**BOARD OF ZONING ADJUSTMENT  
STAFF REPORT**

5894

85 Schillinger Road North  
(Northwest corner of Schillinger Road North and Airway Park Drive).

**VARIANCE REQUEST**

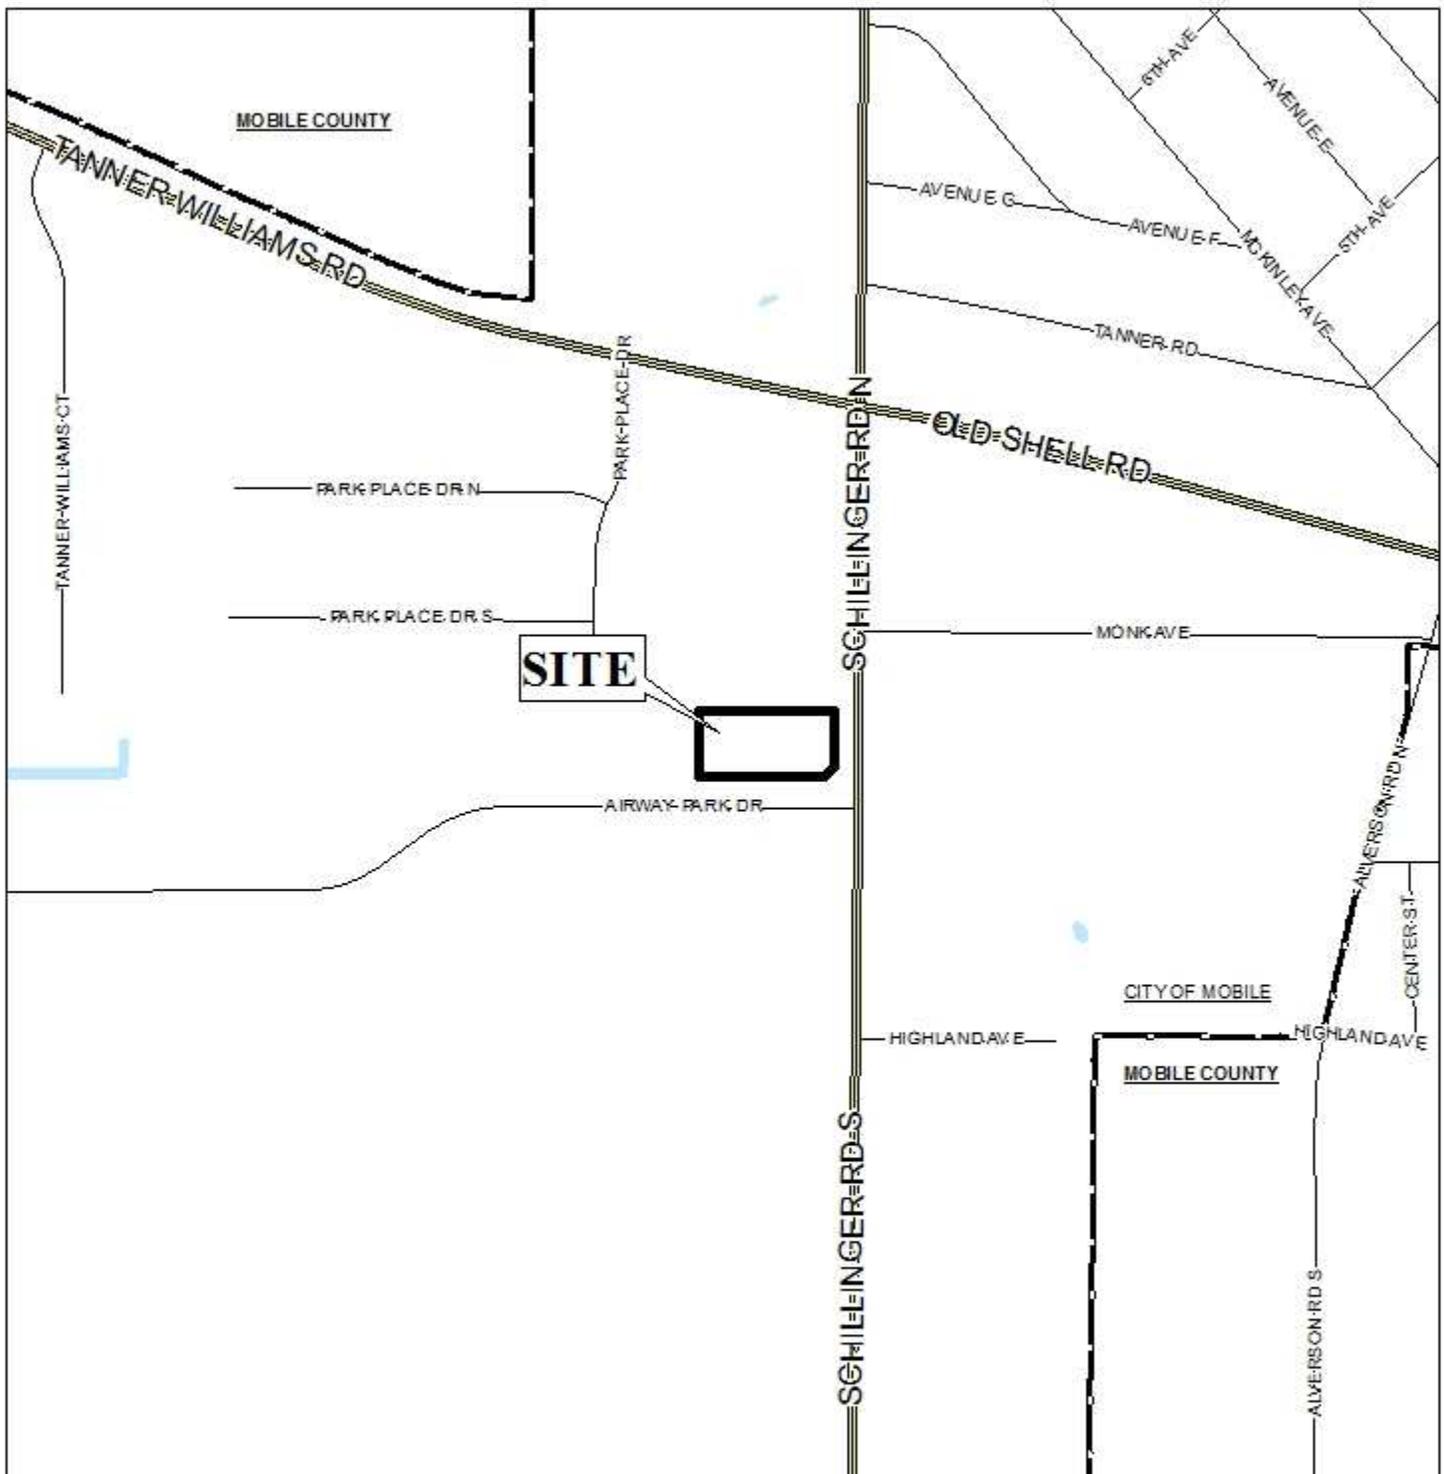
The applicant states that the lot utilized for storage of the vehicles will store approximately 30 vehicles. However, the plans submitted do not depict the number of parking spaces nor does it delineate how the cars will be stored on the property. Based upon staff’s review the site would only be able to store approximately 24 cars in accordance with the standard 9’ x 18’ dimensions and 24’ wide access aisle as required by the Zoning Ordinance.

The plan fails to illustrate any wheel stops, bumper stops, or curbing for the parking spaces as required by Section 64-6.3 of the Zoning Ordinance.

The plan also fails to depict any trees and landscaping on the site; although staff made mention of the requirements during the plan review. The applicant has failed to ask for a tree and

landscaping variance as well as failed to provide tree and landscaping on the site plan which may possibly reduce the total estimated number of parking spaces. A revised site plan illustrating full tree and landscaping compliance is required, or the applicant must amend the variance application to add tree and landscaping, and provide new mailing labels, notification fees, and the additional variance fee.

The site plan does not illustrate fencing or gates on the proposed plan. If the applicant proposes to provide fencing or gates on the site, it must be depicted on the site plan. If the applicant chooses not to provide fencing or gates on the site plan, neither will be allowed.

It should be noted the site plan submitted does not show the lot line that separates the two lots. A revised site plan illustrating the lots as two separate lots is required.

*The applicant also submitted a revised site plan that depicts the property line that separates the two lots, a total of 20 striped parking spaces, and depicts bumper stops to prevent the vehicles from extending beyond the parking facility as required by the Zoning Ordinance.*

*With regards to the Tree and Landscape Variance request, the site is roughly 13,300 ± square feet and would require a total landscaped area of 1,596 ± square feet, with 958 ± square feet being frontage landscaping, along with 3 frontage trees, 12 perimeter trees, and 1 parking tree. There are currently some trees located to the north of the site and the applicant states that the “existing trees along the northern property line currently serve as a buffer” and “the parking material (gravel) will result in reduced ‘heat island’ affects in comparison to asphalt paved parking areas”. However, additional tree planting and landscaping as required by the Zoning Ordinance would increase the amount of green space and serve as an additional buffer and minimize the “heat island” affects.*

*Although the applicant has submitted a more detailed site plan addressing the previous concerns, the applicant has not provided evidence of a true hardship to justify granting the approval of the variance requests. It is simply the applicant’s desire to use aggregate surfacing for the adjacent lot instead of asphalt or concrete and not provide adequate trees or landscaping as required per the Zoning Ordinance.*

- 1) revise the site plan to depict full tree and landscaping compliance, or submit a revised narrative to include a tree planting and landscaping variance and payment of associated application fees; and notification labels and notification fees;
- 2) revise the site plan to depict the property line between the two separate lots;
- 3) revise the site plan to depict the number of parking spaces and delineate how the cars will be stored on the property; and
- 4) revise the site plan to depict wheel stops, bumper stops, or curbing for the proposed parking spaces.
